**ISD #15 DISTRICT OFFICE BUILDING
4115 AMBASSADOR BLVD.
September 19, 2018**

Title of Item: **Rivers Edge Phase II – Planned Unit Development:** A request from Laketown Homes, LLC, for PUD Development Stage approval (Preliminary Plat), and associated rezoning to a Planned Unit Development (PUD) to establish 30 new lots on 20.2 unaddressed acres to the north of the Rum River Bluffs PUD and to the west of Phase I of the Rivers Edge PUD; PID: 32-34-24-21-0001.

City of St. Francis Planning Department
Rivers Edge PUD Phase II Development Stage Plan Review

PRELIMINARY SANITARY SEWER & WATERMAIN PLAN	PROJECT NO. 18-030
SHEET NO. 5 OF 10 SHEETS	DATE: 07/31/2018

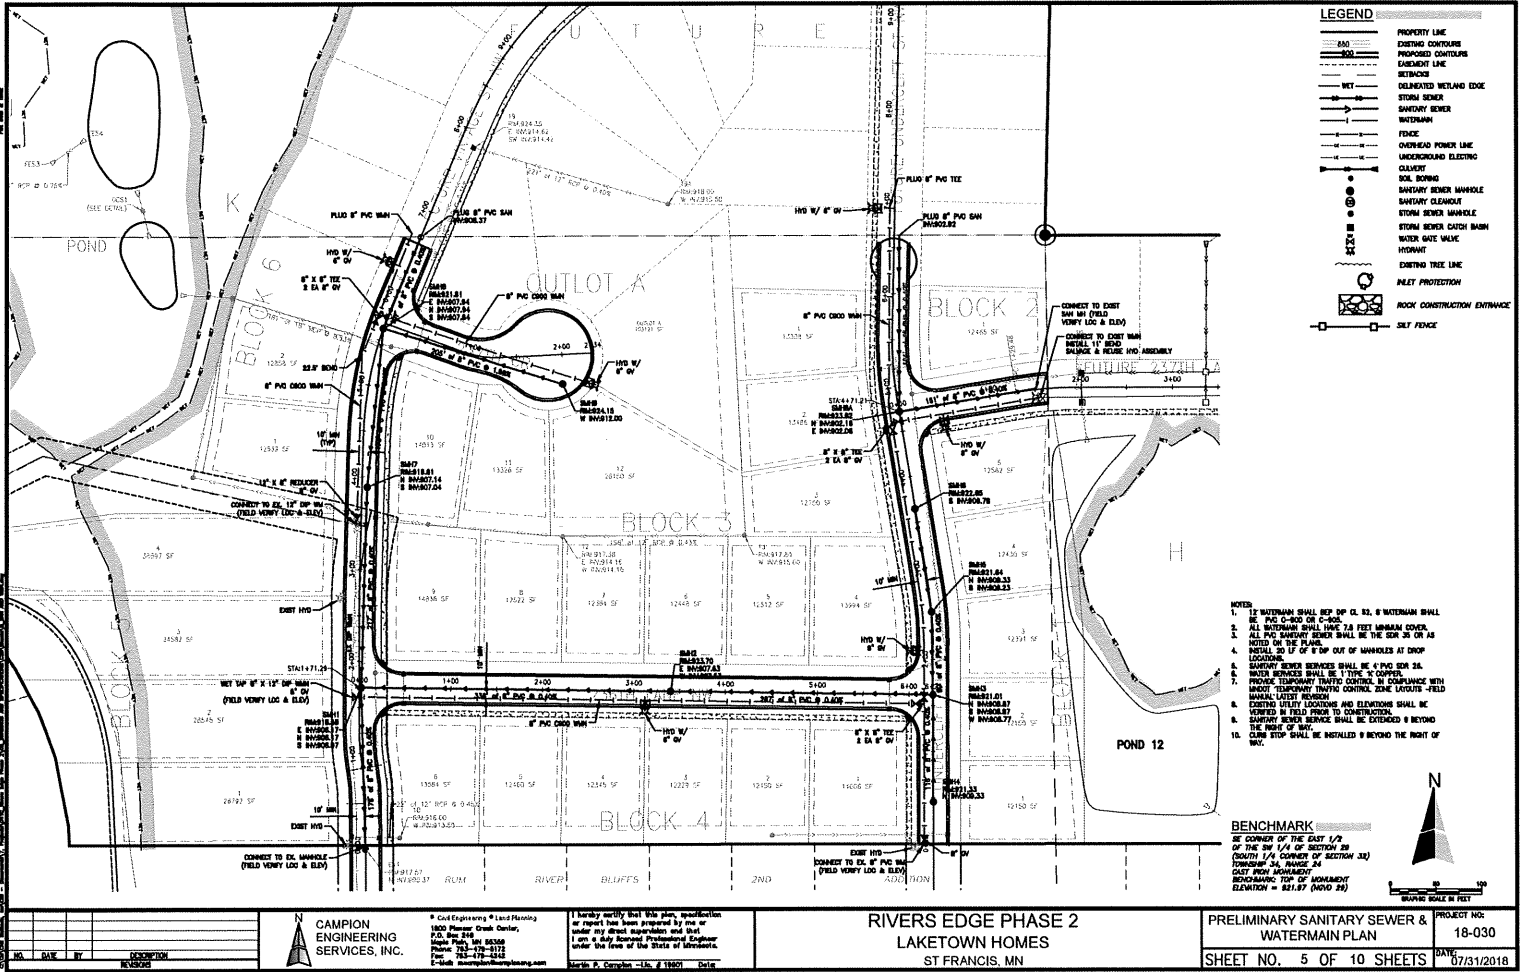
2. City standards require sanitary sewer manholes to be located on the centerline of the street. SMH7 is not located in the centerline of the roadway, please revise as necessary.

3. City standards require sanitary sewer manholes to be located on the centerline of the street. SMH7 is not located in the centerline of the roadway, please revise as necessary.
4. Clearly label the existing watermain, including sizes and material, on the preliminary utility plan.

1. As per Sewer and Water Utilities comment 3 above, sanitary sewer manholes are required to be located on the street centerline. Revise street and lot arrangement as necessary to allow for SMH7 to be located on street centerline.

PRELIMINARY STREET & STORM SEWER PLAN

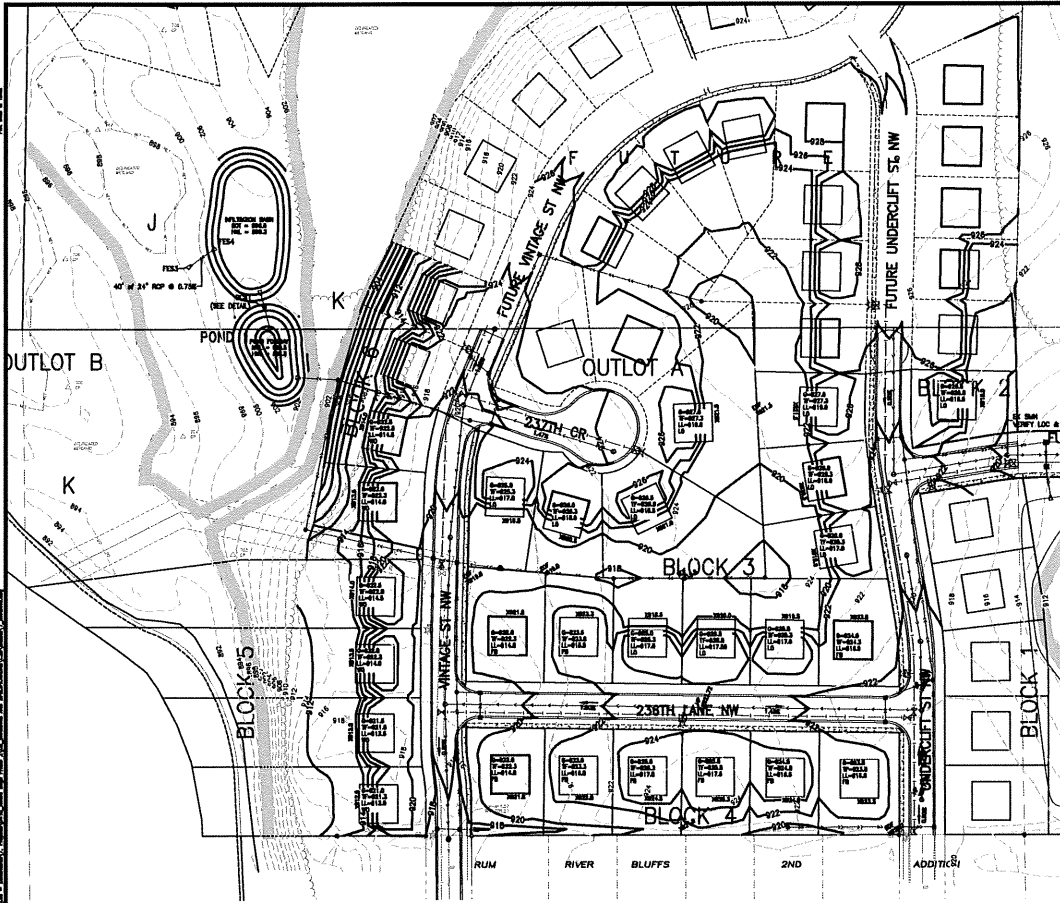
3. Access to storm structures and/or stormwater basins shall not cross wetland areas. It will be necessary to provide an access route on the north side of the large wetland complex.

3. Access to storm structures and/or stormwater basins shall not cross wetland areas. It will be necessary to provide an access route on the north side of the large wetland complex.

PRELIMINARY GRADING PLAN	PROJECT NO. 18-030
SHEET NO. 7 OF 10 SHEETS	DATE 07/31/2018

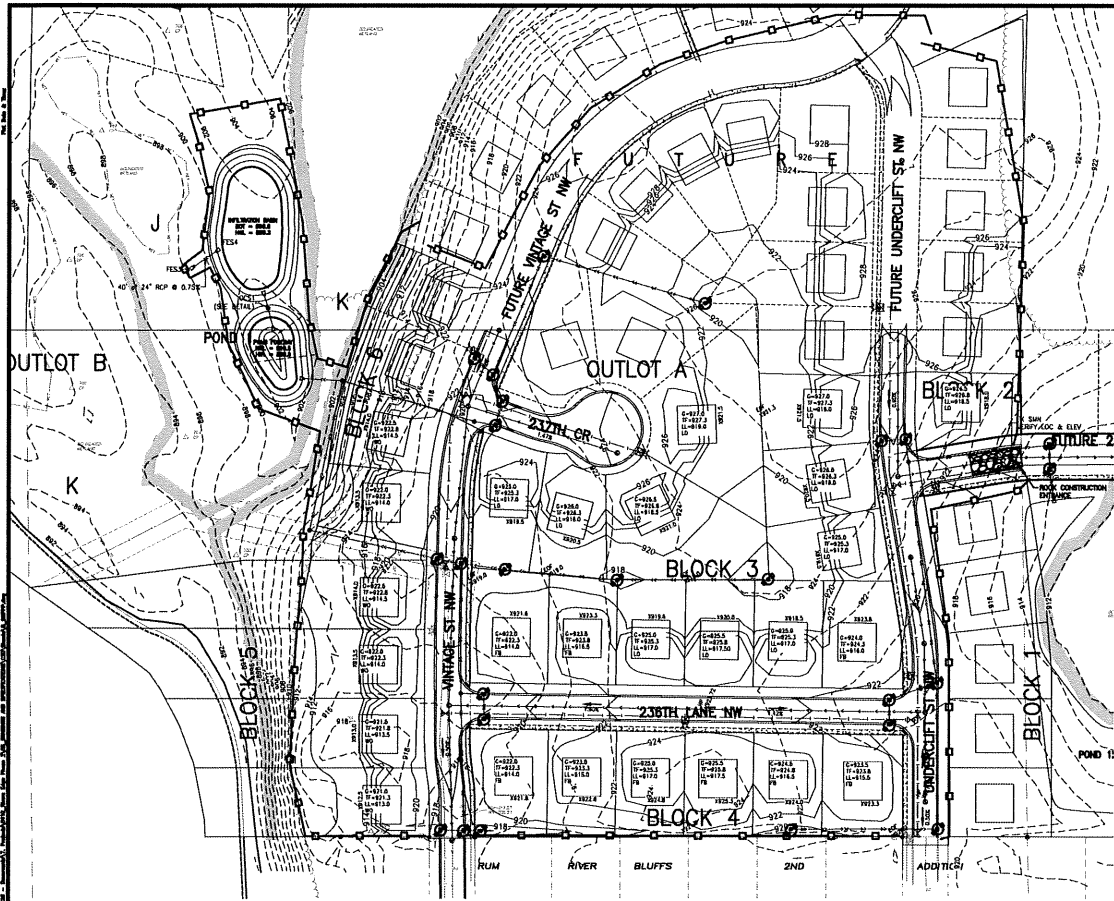
4. The emergency overflow elevation between Block 5 and Block 6 west of Vintage Street shall be labeled on the plans.
5. The emergency overflow along Vintage Street for Lot 6 Block 4 and Lot 1 Block 5 shall be labeled on the plans.

6. All lowest openings are required to be 1.5 feet above the emergency overflow elevations (10-93-6.E.4). Please provide proposed lowest opening elevations and ensure the 1.5 foot separation is met.

7. Please label the proposed house elevations as per the approved Grading Plan for the adjacent lots in Rum River Bluffs 2nd Addition, abutting to the south of this proposed plat.

8. It does not appear that the proposed emergency overflow elevation provides 1.5' of separation from the lowest opening elevation in Rum River Bluffs Lot 2 Block 3. Per the approved Grading Plan, the lowest opening for Lot 2 Block 3 is 921.5, therefore the emergency overflow shall be 920 or lower.

9. A proposed spot elevation of 918.0 is depicted in the rear yard of Lot 1 Block 2. The preliminary grading plan proposes a look out house type for this lot with a lowest level elevation of 918.5, therefore it appears that the spot elevation is incorrect. Please correct.
